Department of Energy

January 17, 2003

**Response to Defense Nuclear Facilities Safety Board (DNFSB) Comments
in DNFSB Letter dated November 4, 2002**

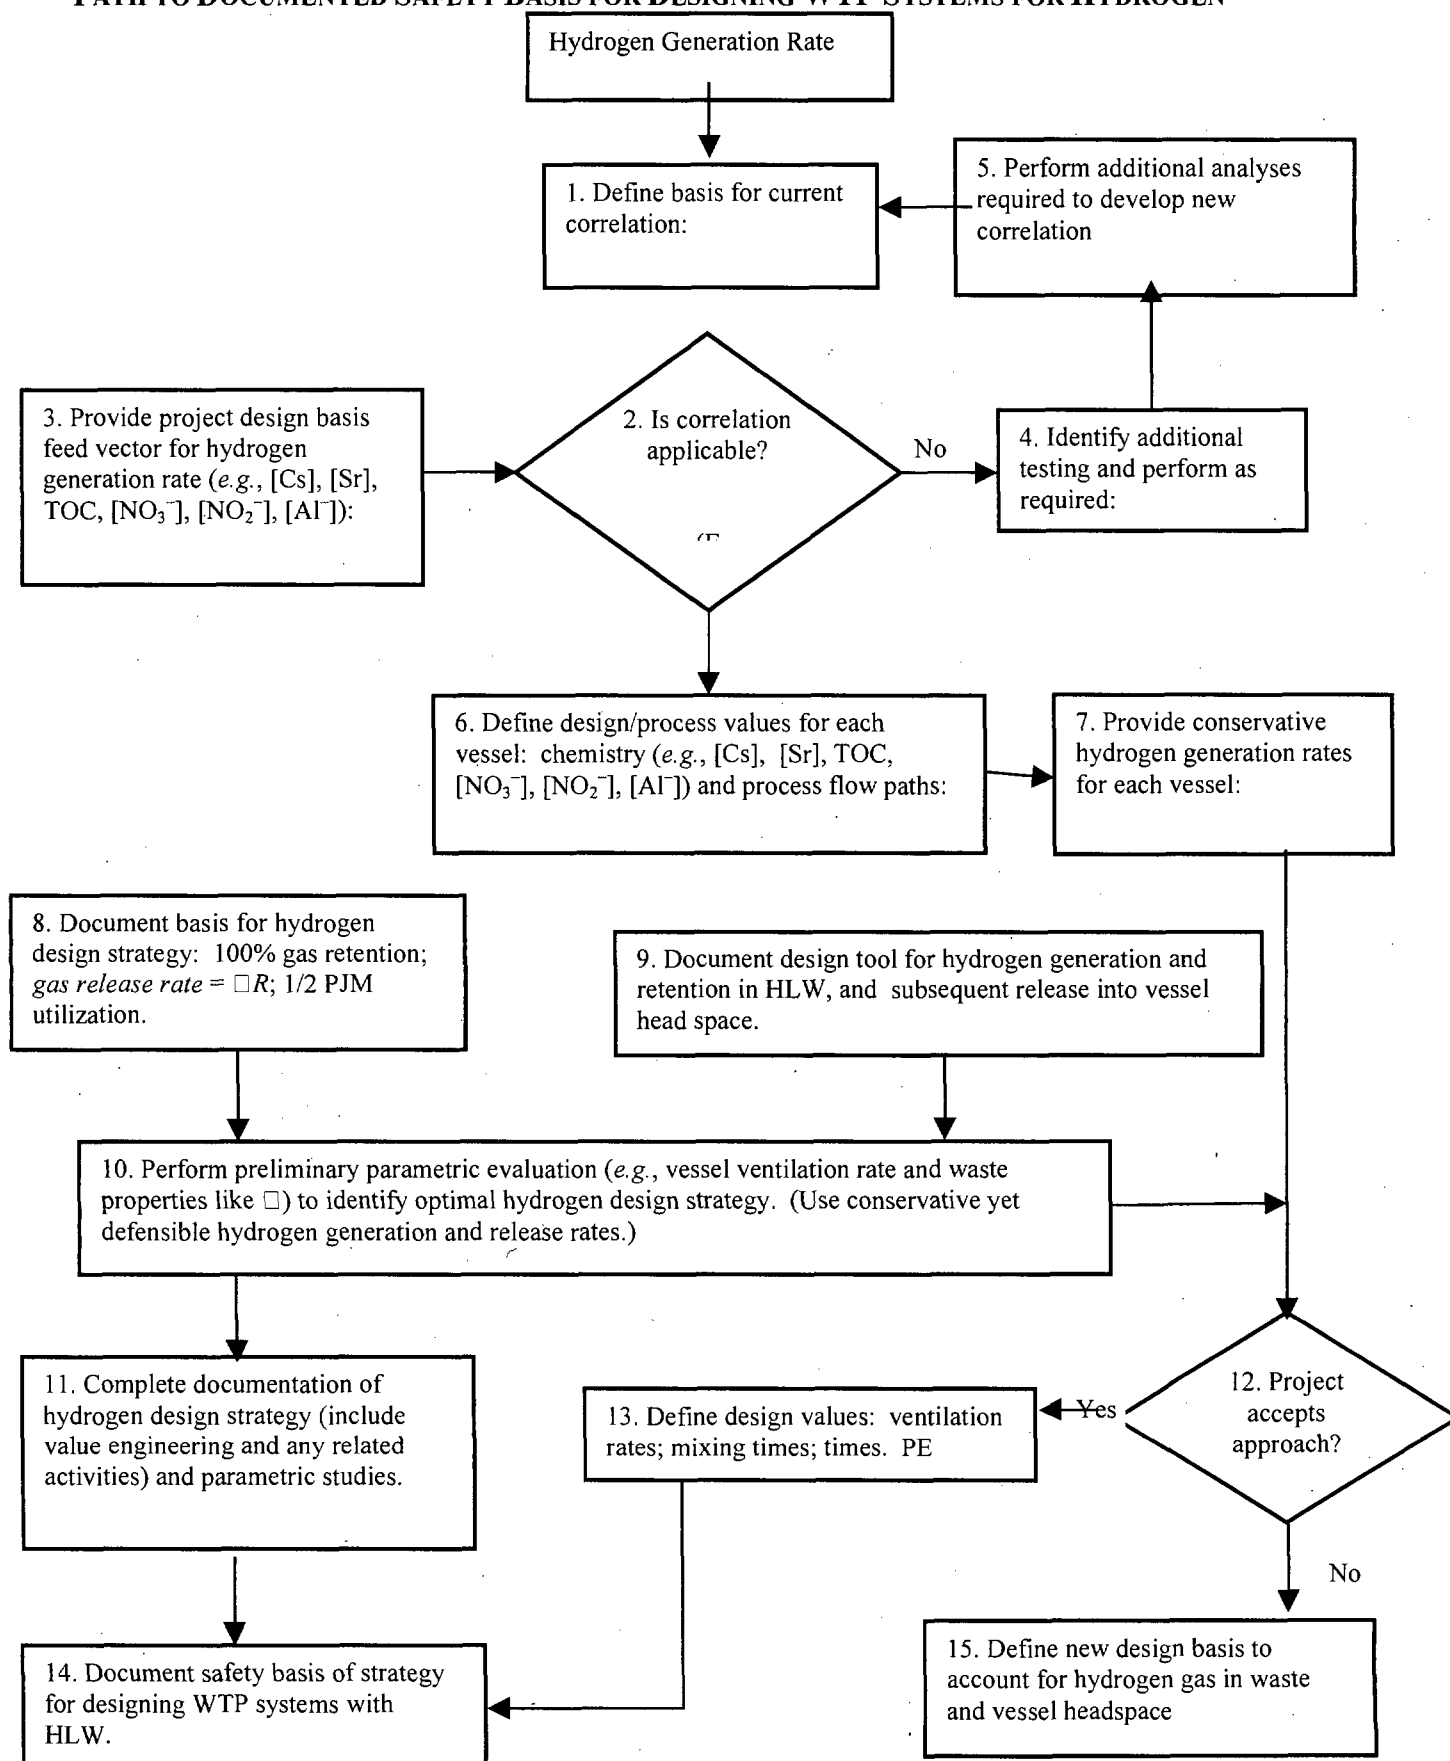
Hydrogen is a significant hazard within the WTP. The current control strategy is to maintain hydrogen concentrations below 25 percent of the lower flammability limit (LFL). BNI's design approach involves providing sufficient dilution ventilation during all plant conditions (e.g., normal operating and upset conditions) and therefore requires an accurate understanding of hydrogen generation rates within each WTP vessel. Dilution air is provided by the process vessel purge (PVP) system.

In at least one instance, the model underpredicted by approximately 25 percent the hydrogen generation within Tank AW-101 compared to that tank's measured generation rates. This discrepancy is significant as Tank AW-101 will provide feed during the initial WTP operating period (Phase 1). Moreover, this discrepancy demonstrates that the current model may not yield conservative or bounding hydrogen generation rates. A proper understanding of the driving mechanisms behind hydrogen generation and the sensitivity of various inputs is required, rather than an increase in the conservative estimates for some individual inputs. Additionally, as the PVP system is currently in design and nearing procurement, a sufficiently conservative predictive model for hydrogen generation rates needs to be developed in a timely manner.

BNI has chosen to model hydrogen generation rates using a model developed for the tank farms. This model was developed in the early 1990s to better understand flammable gas generation in Tank SY-101. This approach may not produce sufficiently conservative generation rate values since it does not address other important variables involved in hydrogen generation. In at least one instance, the model underpredicted by approximately 25 percent the hydrogen generation within Tank AW-101 compared to that tank's measured generation rates.

DOE agrees that using the 1997 hydrogen model developed for the tank farms and conservative input values to model hydrogen generation rates may not produce sufficiently conservative generation rate values.

In light of the issues raised by the DNFSB staff regarding the shortcomings of the correlation, (i.e., under prediction and no consideration of alpha), an effort was undertaken to demonstrate that by using conservative input parameters, including the effect of alpha emitters, a bounding defensible hydrogen generation rate could be developed. The plan to remove uncertainty in the understanding of hydrogen generation is shown graphically in the following Figure.

BNI has completed the activities identified in boxes 1 through 7 of the Figure, and concluded the correlation identified in RPT-W375-SA00002 is not a conservative methodology for predicting hydrogen generation rates (See 24590-WTP-RPT-RT-02-006, *Predicting Hydrogen Generation Rates in Radioactive Waste Materials* for further discussion) (referred to as the R&T report). Using conservative input values for envelopes A and B the Topical Report correlation under predicted hydrogen generation in Tank AW-101; however, for envelope C, the correlation over predicted hydrogen generation in Tank AW-101.

The activities shown in blocks 8 and 9 of the previous Figure have been completed (24590-101-TSA-W000-0004-120-03 *Analytical Models Describing Global Hydrogen Retention and Release in WTP Mixing Vessels* [CCN: 048258]). This report characterizes and discusses the following:

required to purge the vessel headspace and provide drive air to the PJMs. Therefore, conservative design/process variables for each pretreatment vessel are being developed and documented, and hydrogen generation rates and times to LFL are being calculated for designing the Safety Design Class hydrogen preventive/mitigative systems. PJM operation is also being evaluated to develop PJM utilization, mixing durations and cycle times (quiescent or Q times). These activities are identified in Blocks 6, 7, 10, 11, and 13.
